# Service Bulletin

Bulletin No.: PI0924B

**Subject:** Intermittent Unwanted Trunk Opening While Vehicle is Parked

**Models:** 2010-2014 Buick LaCrosse  
2011-2014 Buick Regal  
2012-2014 Buick Verano  
2011-2013 Chevrolet Cruze  
2012-2013 Chevrolet Sonic (4 Door Sedan Only)  
2013-2014 Chevrolet Malibu

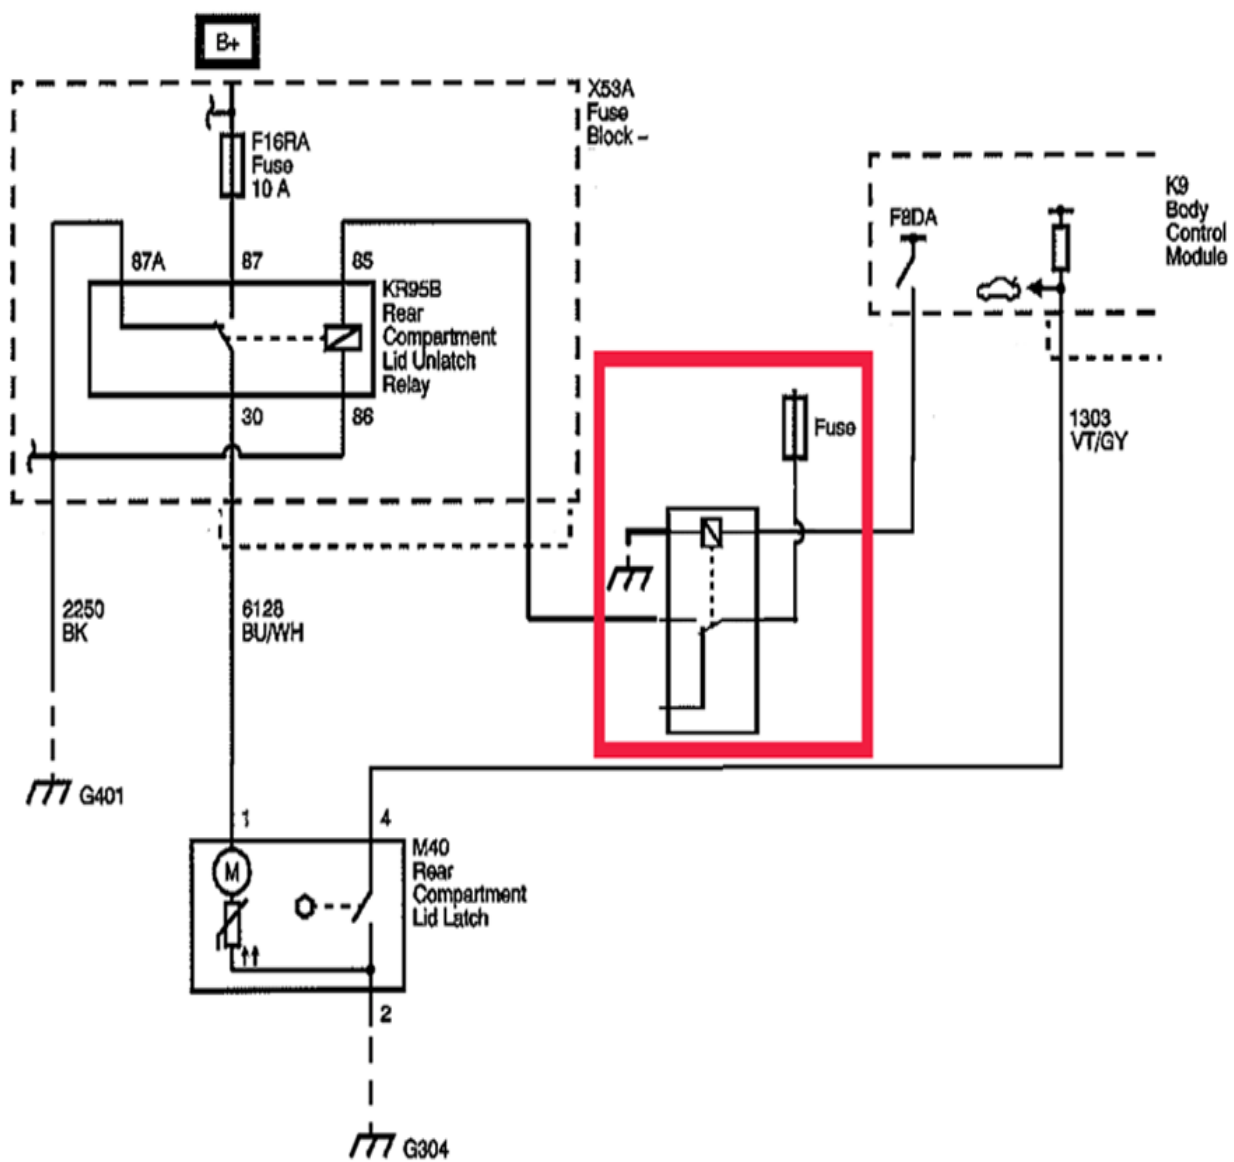
Replace the KR95B Rear Compartment Lid Unlatch Relay with a "Two Shot Relay", GM P/N 19119267, using the applicable procedure below. When installed, the remote transmitter (key fob) trunk release button, the exterior rear compartment lid release switch (touch pad) or the interior rear compartment lid release switch must be pressed twice within three seconds to release the trunk.

Remove the KR95B Rear Compartment Lid Unlatch Relay located in the X51A Instrument Panel Fuse Block and install the "Two Shot Relay."

3329904

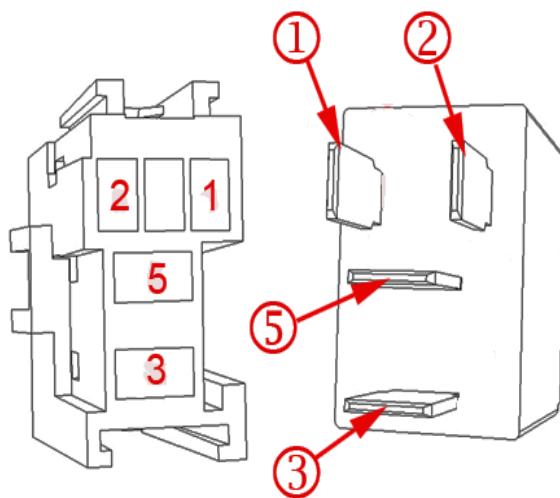
The rear compartment lid unlatch relay is part of the printed circuit board in the relay/fuse block and not serviceable separately. Installation of an external relay circuit to bypass the feed to the trunk release control will be required. Install the "Two Shot Relay" adjacent to the BCM and attach a tag to the relay and mark with "Two Shot Trunk Relay per Bulletin PI0924." For future diagnosis for an inoperative trunk release, this relay installation will be identified before a BCM is replaced.

1. Label the four leads of connector, P/N 12126045 as indicated below.
2. Connect the connector to the new relay, P/N 19119267.
3. Locate circuit 6188 (trunk release control) at the BCM following service information. Cut the wire and splice the BCM and relay side of the circuit as shown below.
4. Connect wire fused, unswitched power and ground as shown below.
